**In the Drawings**

### **REMARKS**

FIG. 6

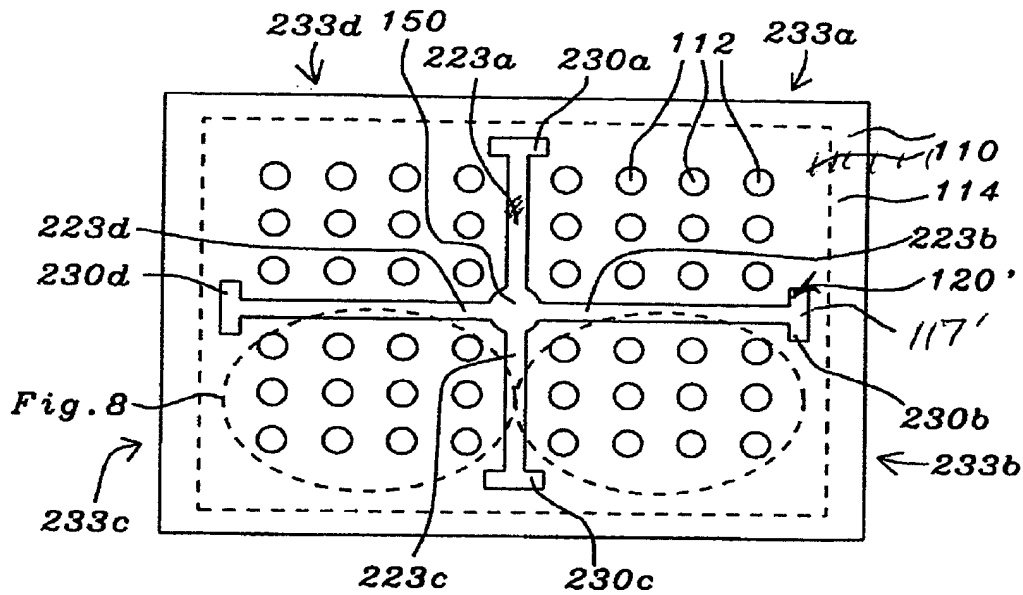
The drawings were objected to as not showing every feature of the claims (e.g. the metal trace structure being X-shaped, as claimed in claim 5, and the metal structure including a channel as claimed in claim 1).

The drawings were also objected to as being improperly cross-hatched.

As noted above, Figs. 3, 5, 6, and 8 have been amended herein, as noted in the accompanying annotated drawing sheets. Also, new Figs. 9 and 10 have been added to illustrate the X-shaped structure that was specifically described in the specification (and claimed). As the subject matter of these drawings was described in the originally-filed specification, the addition of Figs 9 and 10 adds no new matter to the application. Also, the replacement drawing sheets have provided better spacing of the figures (by providing two figures per sheet, rather than three).
